**ATLANTIC COAST PIPELINE, LLC  
ATLANTIC COAST PIPELINE**

**DOMINION TRANSMISSION, INC.  
SUPPLY HEADER PROJECT**

**Revised Site Specific Geohazard Mitigation Design Drawings**

Date: 22 December, 2016  
To: Colin Olness, Dominion  
Copies to: Tony Rice, Geosyntec Seattle  
From: Logan Brant, Geosyntec Houston  
Subject: Revision C Updates to Site Specific Geohazard Mitigation Design Drawings  
MNF and GWNF Sites - Atlantic Coast Pipeline  
Geosyntec Project: TXG0007 / 013 / 1210

SECTION C-C' (STA 5351+00)

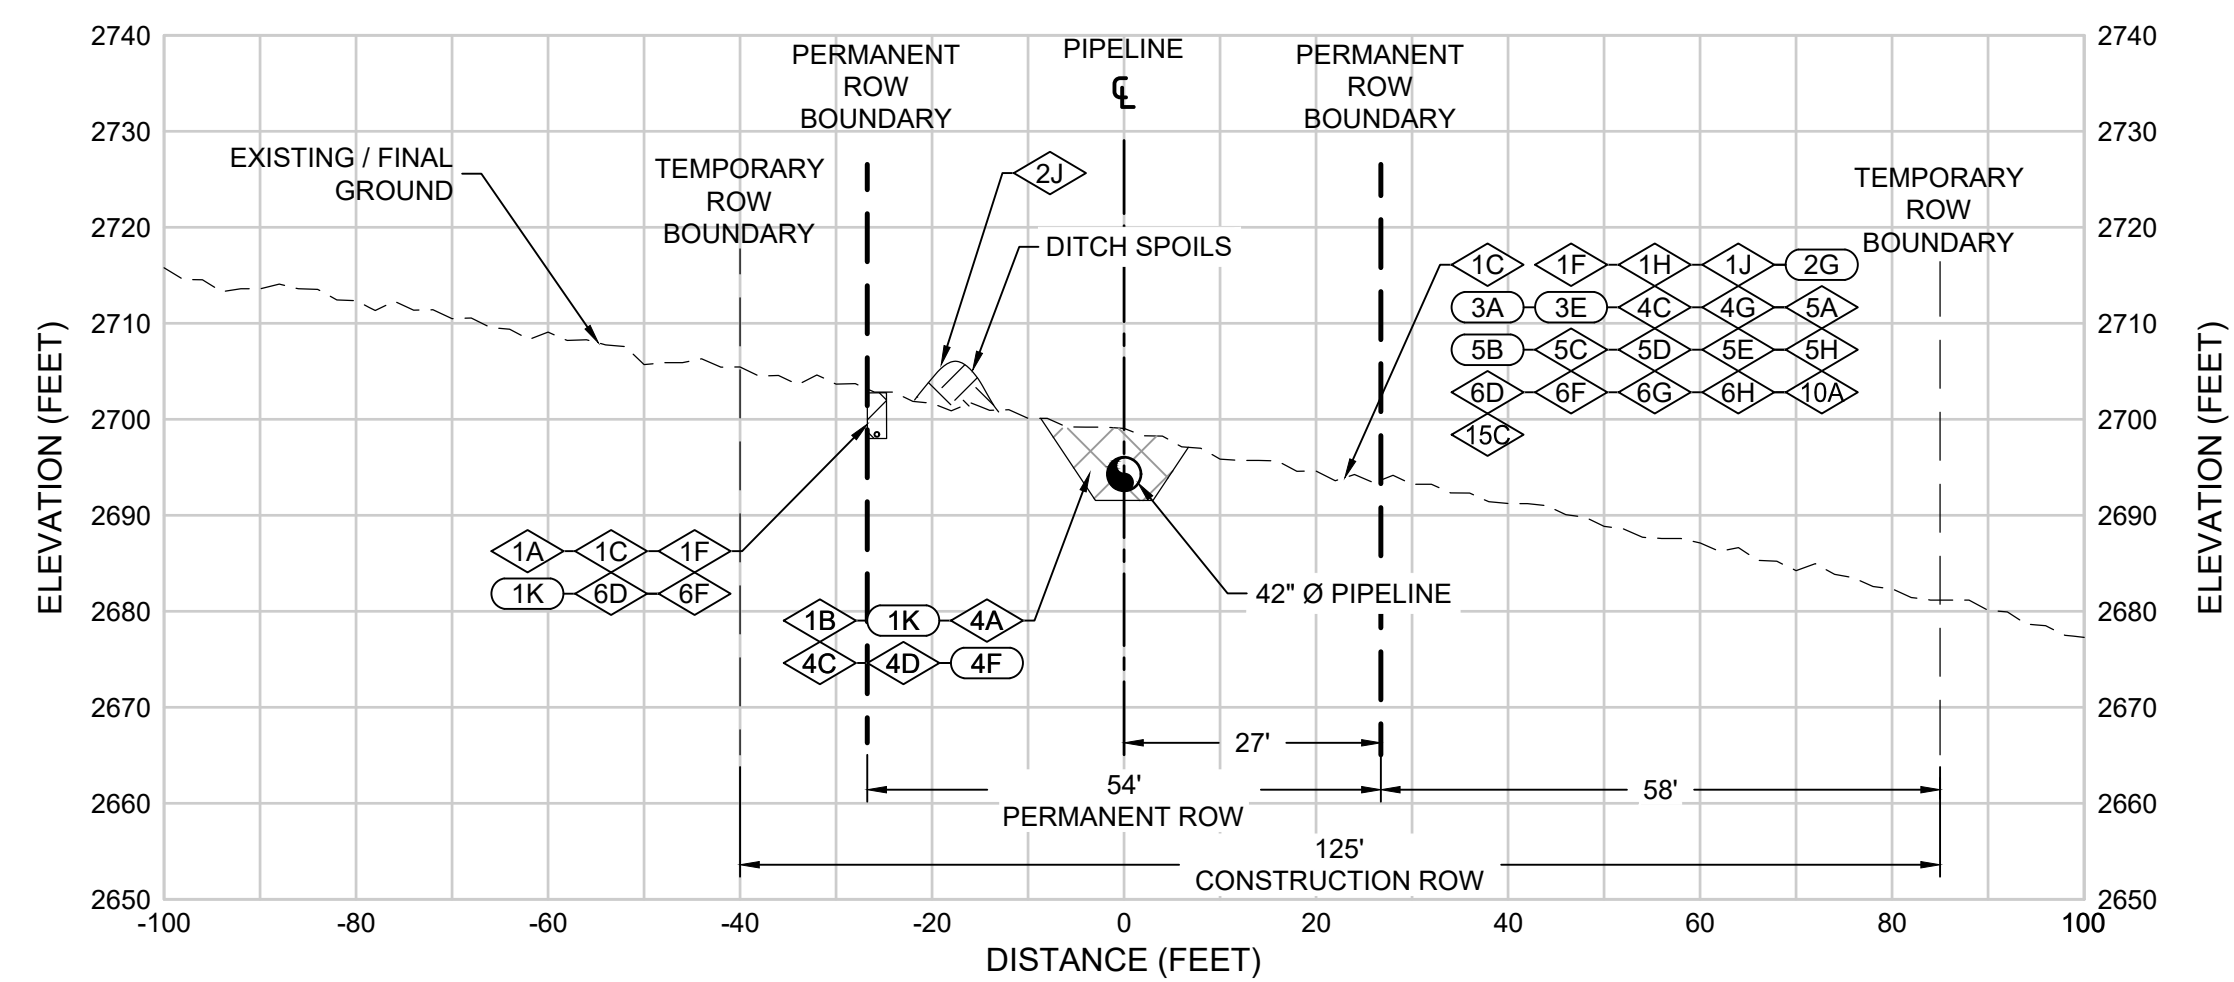
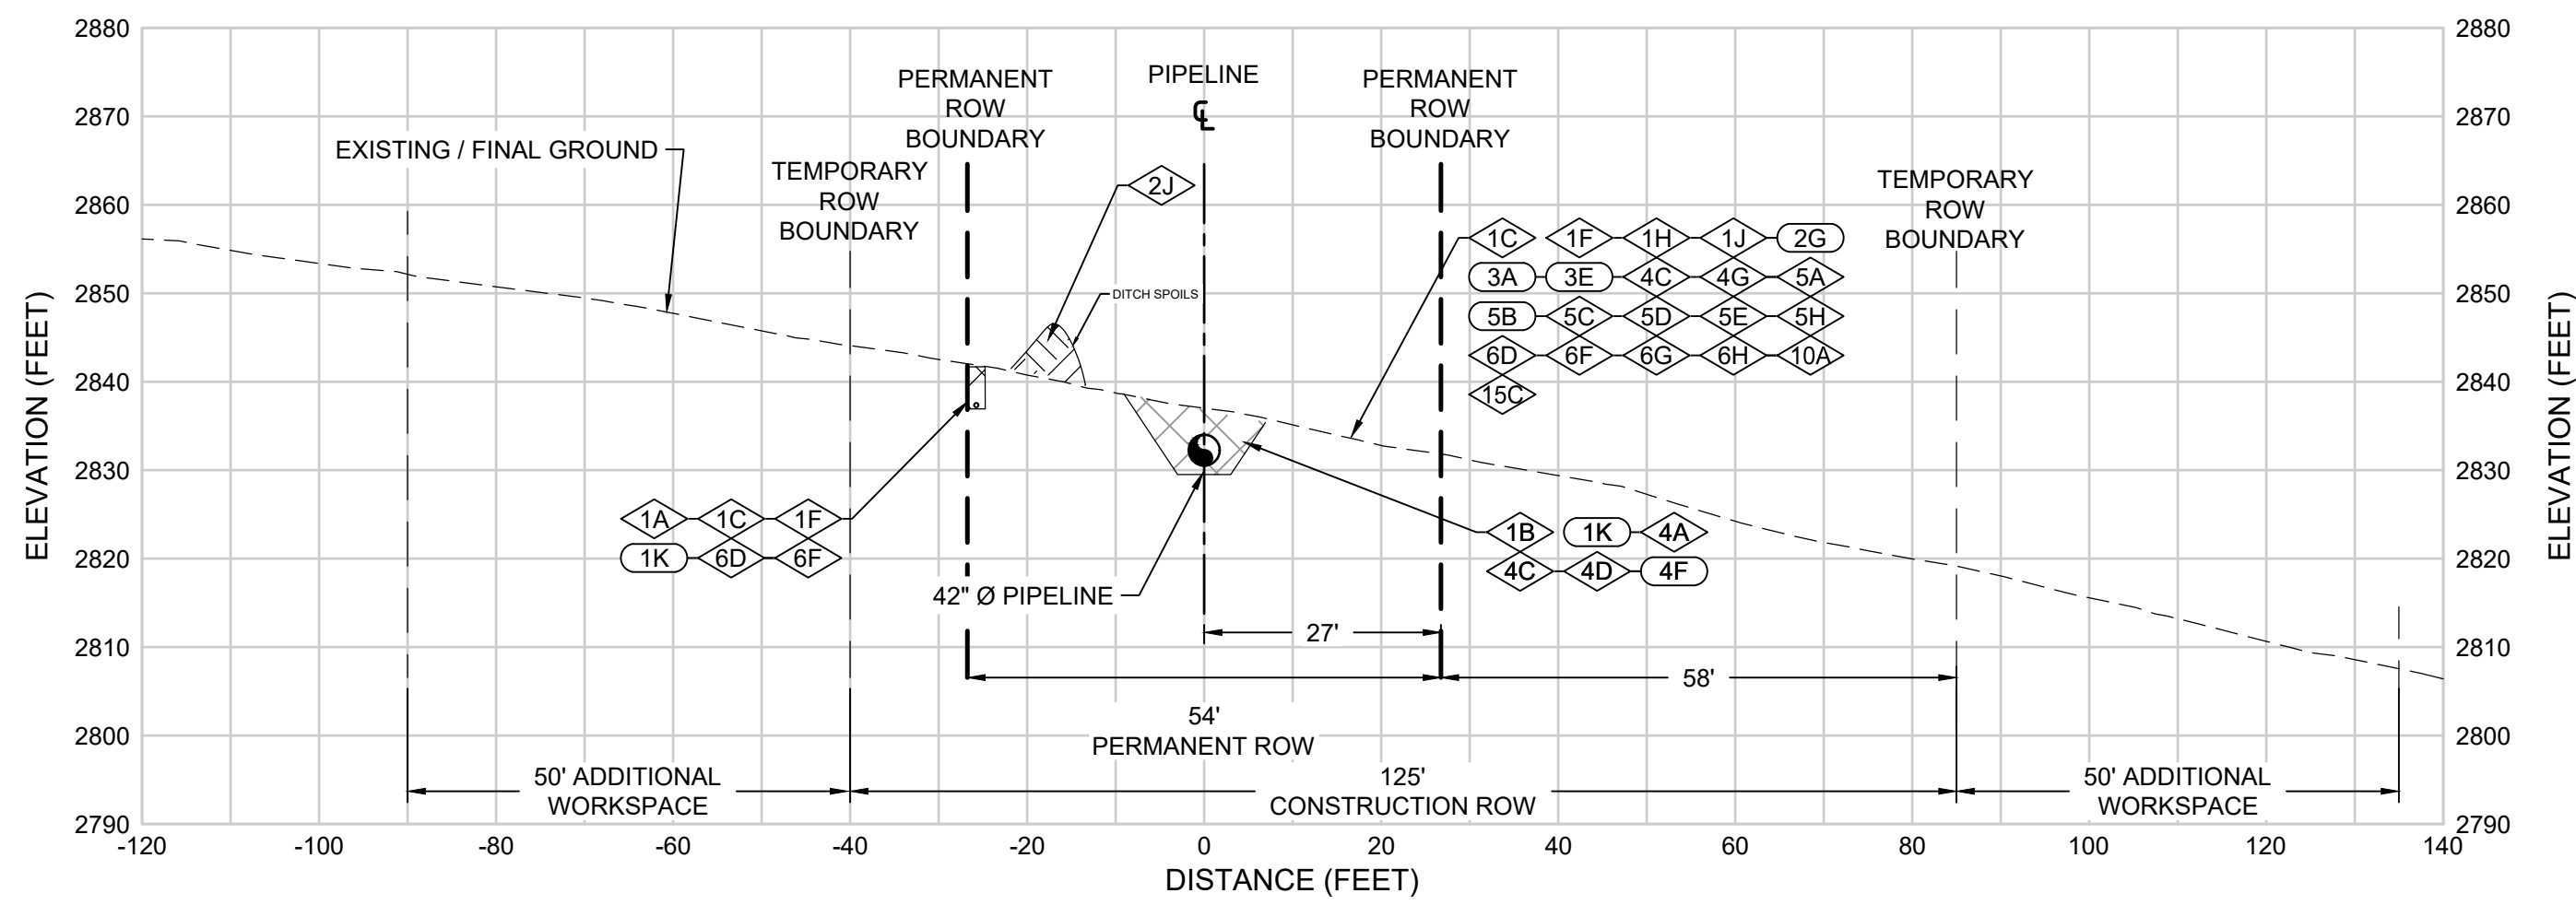
ACP AP-1 MP 84.95 to 85.05 – Sections B-B' and C-C':

- Remove dimensions and label for outdated additional temporary work space in Section B-B'.
- Section C-C' moved to STA 5351+00, in order to include additional temporary work spaces, located near the top of the slope.
- Changed “Existing Ground” labels to “Existing / Final Ground” on sections.
- Changed the scale of the sections on this drawing to 1”-40' (11x17), in order to show wider limits at revised Section C-C'.
- Revision C line added to the revision block.

- Drawing set expanded from 4 to 5 drawings, so drawing numbering now shows “of 5”.

SECTION D-D' (STA 5346+50)

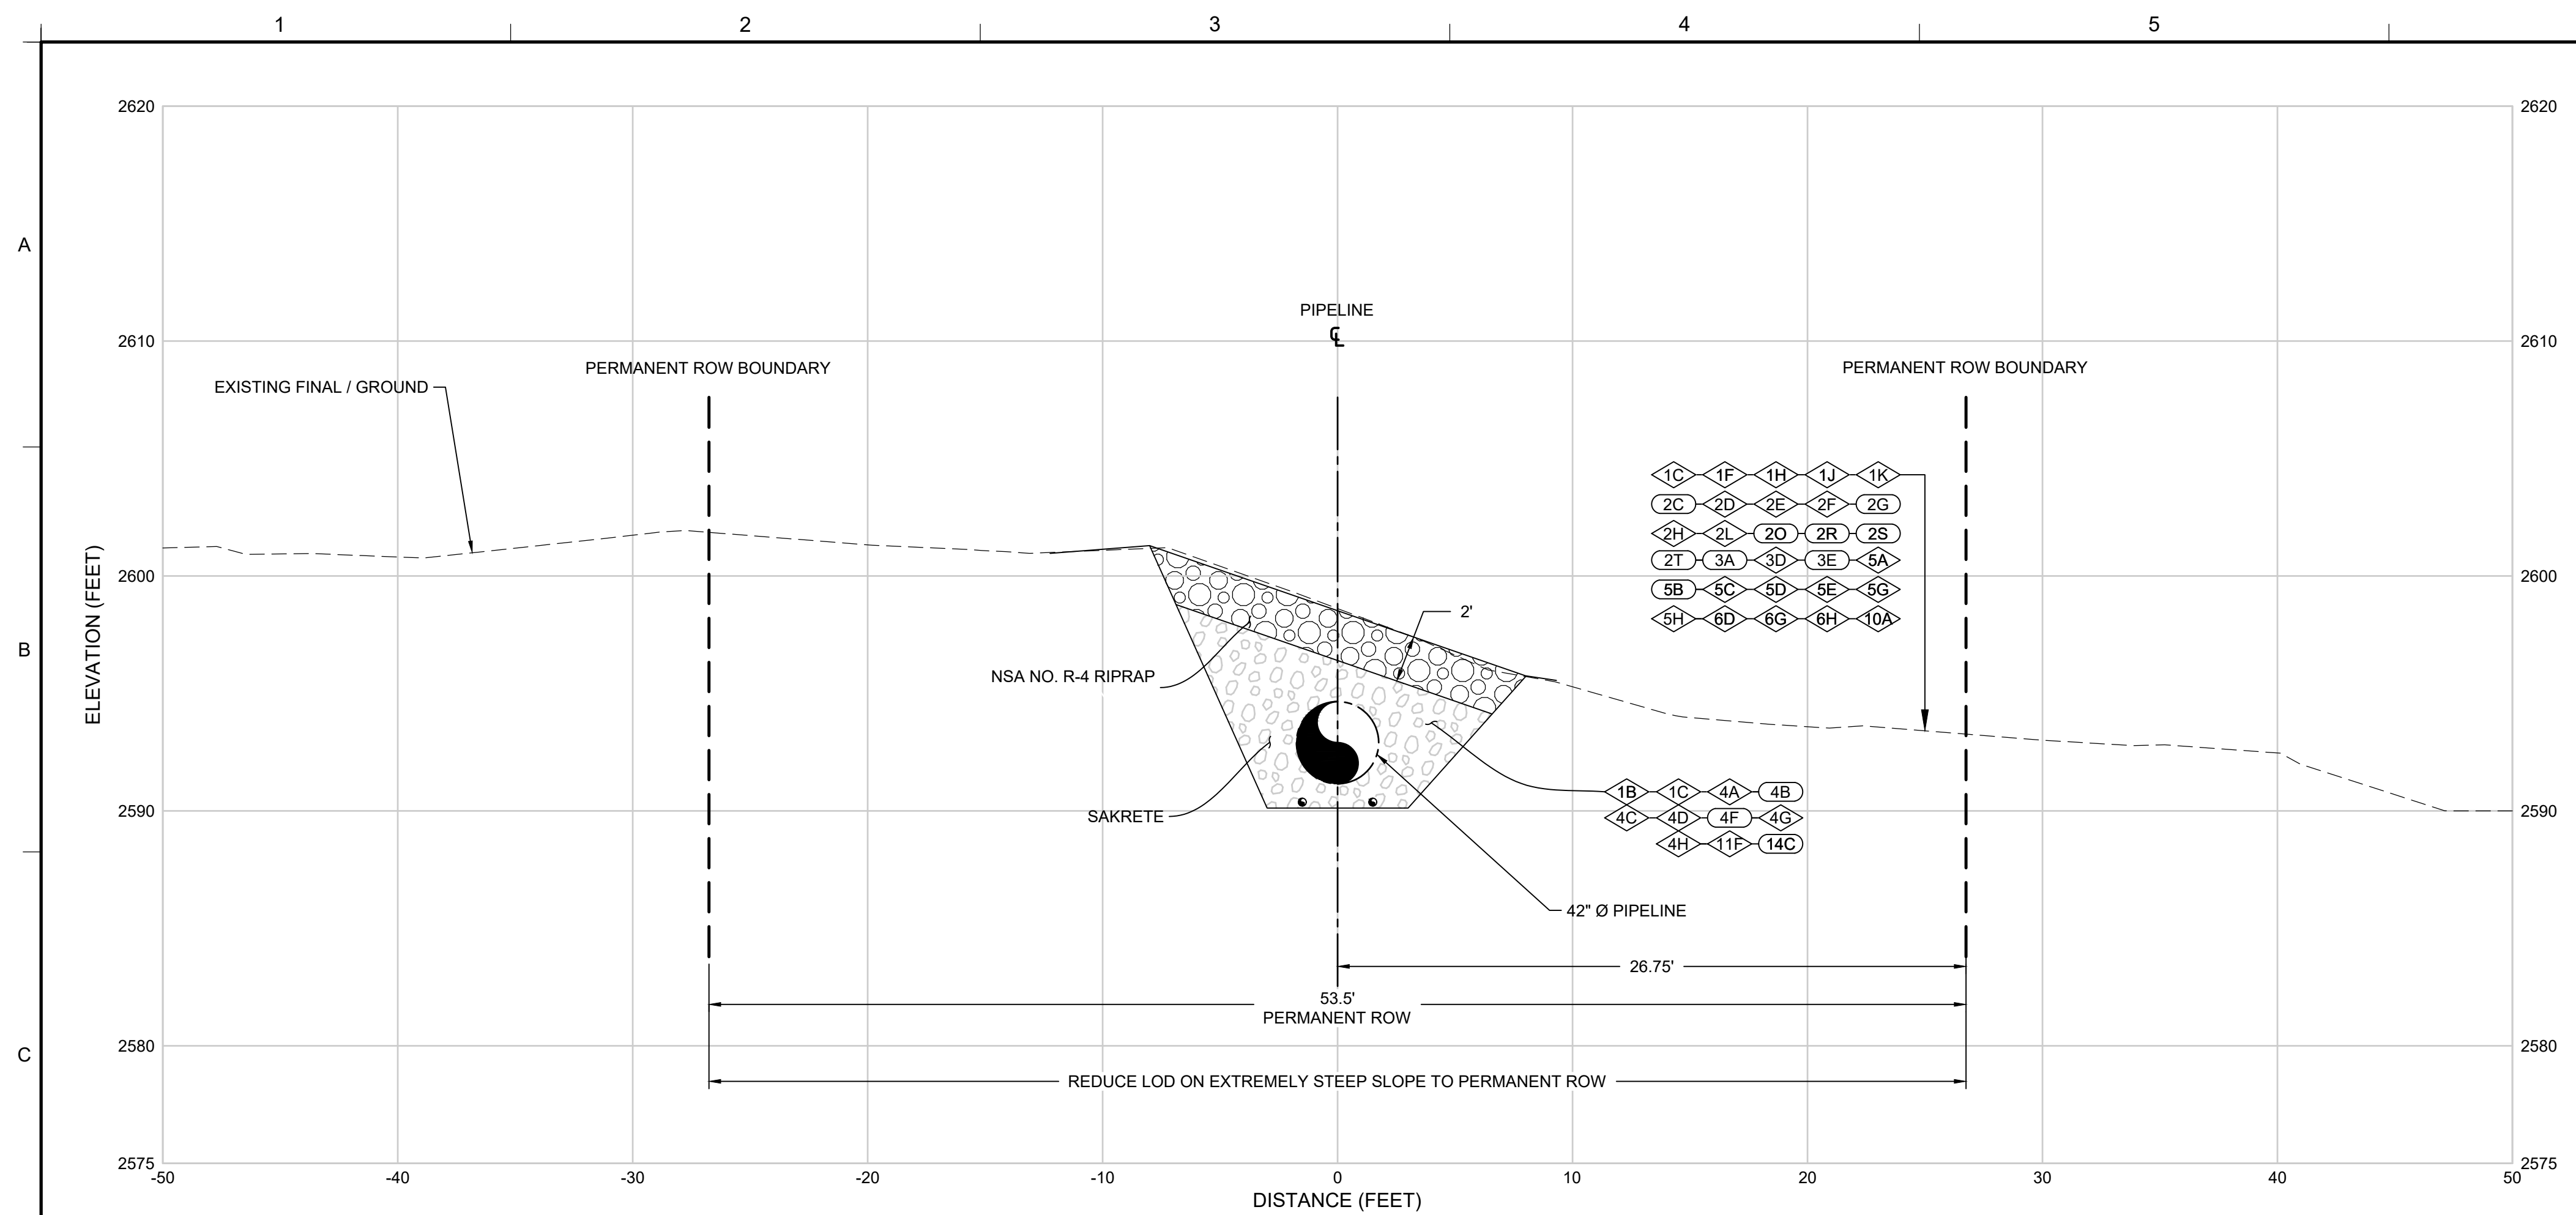
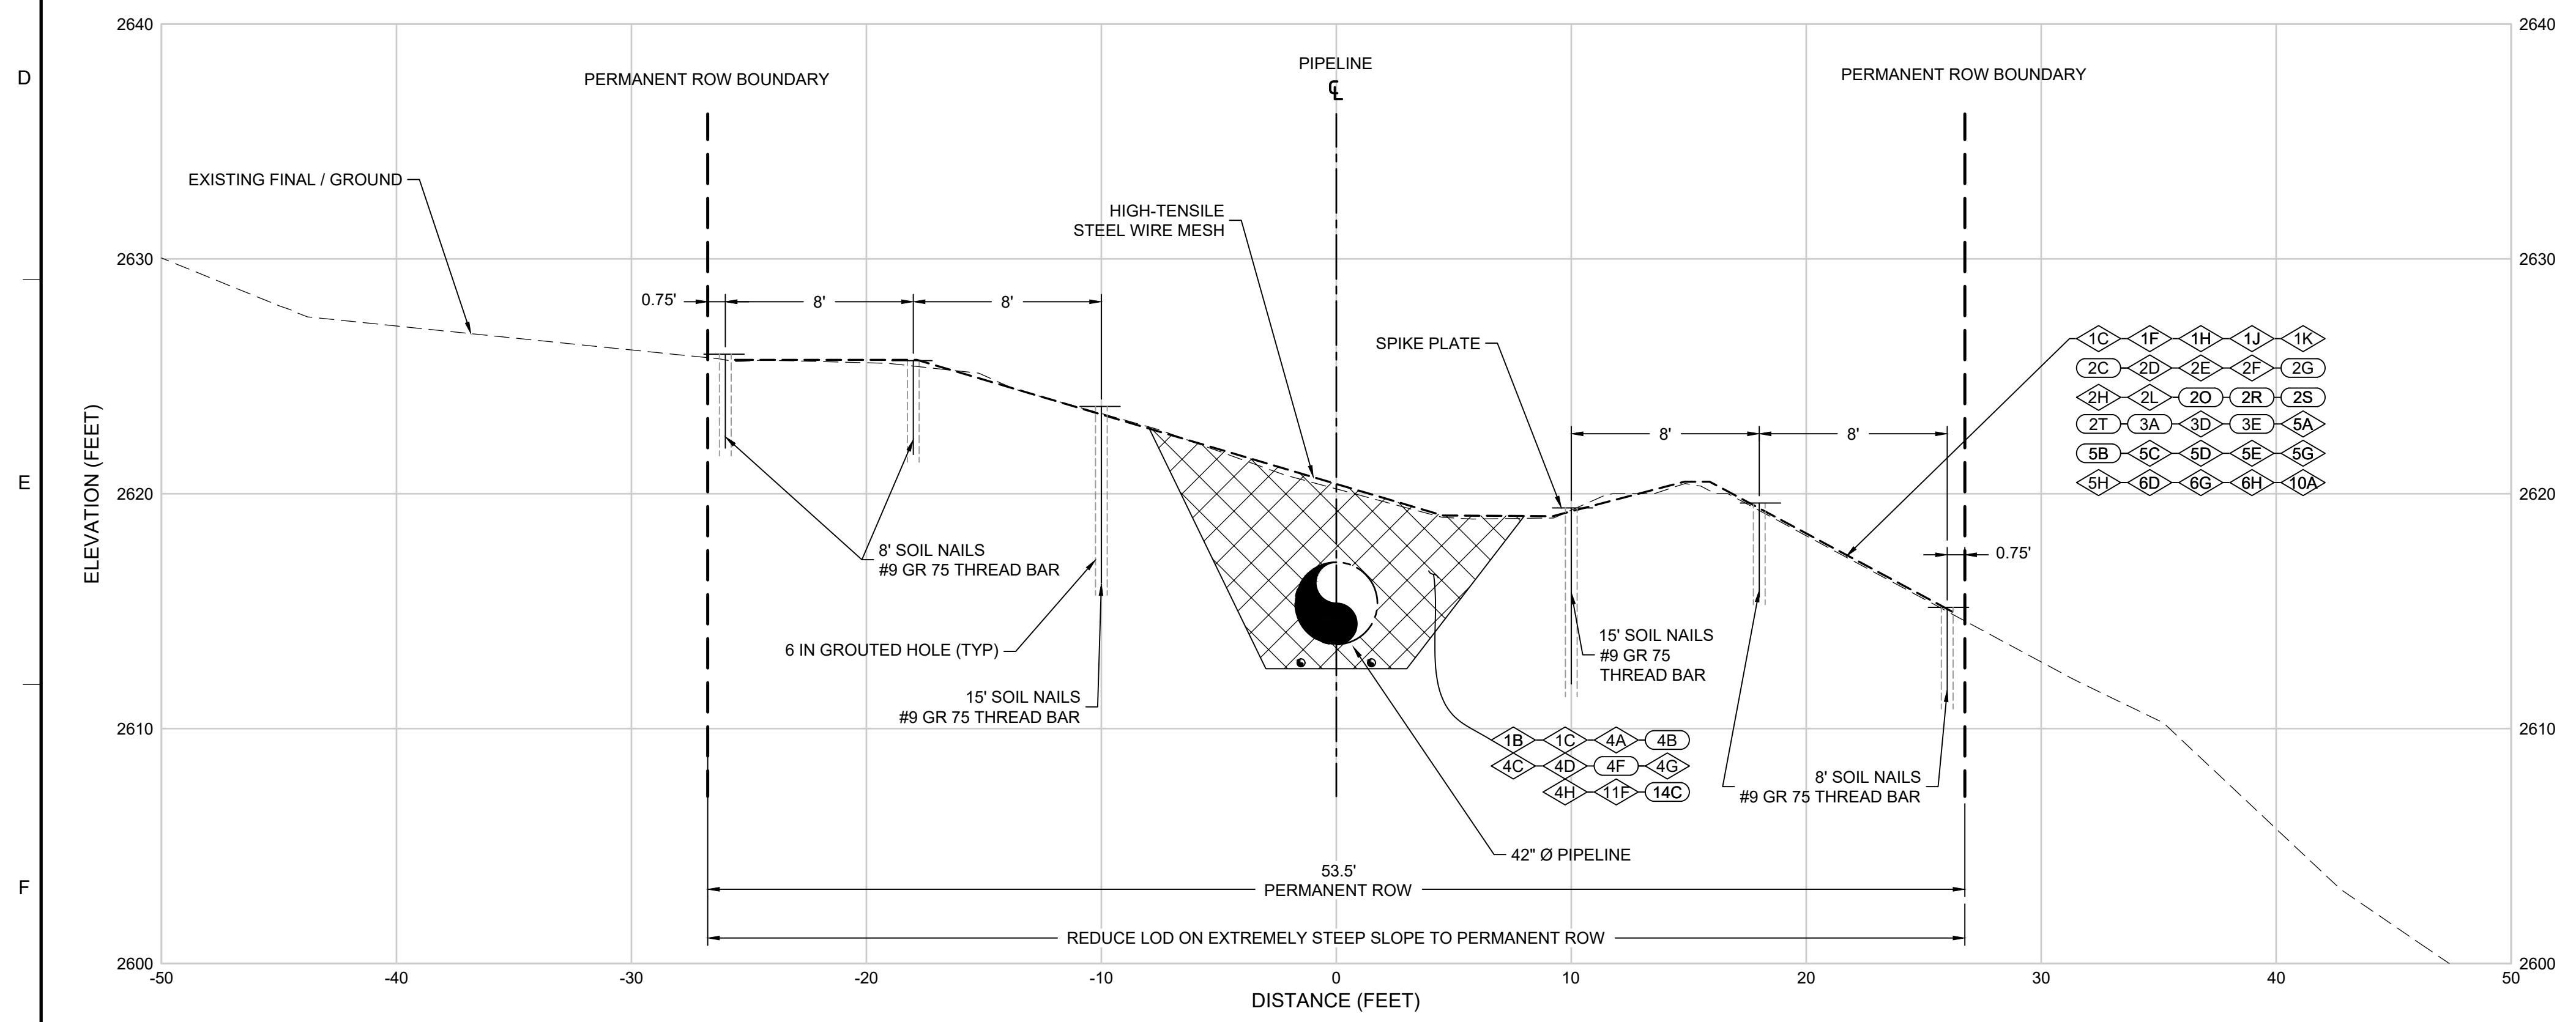
ACP AP-1 MP 84.95 to 85.05 – Sections D-D’ and E-E’:

- Changed “Existing Ground” labels to “Existing / Final Ground” on sections.
- Revision C line added to the revision block.
- Drawing set expanded from 4 to 5 drawings, so drawing numbering now shows “of 5”.
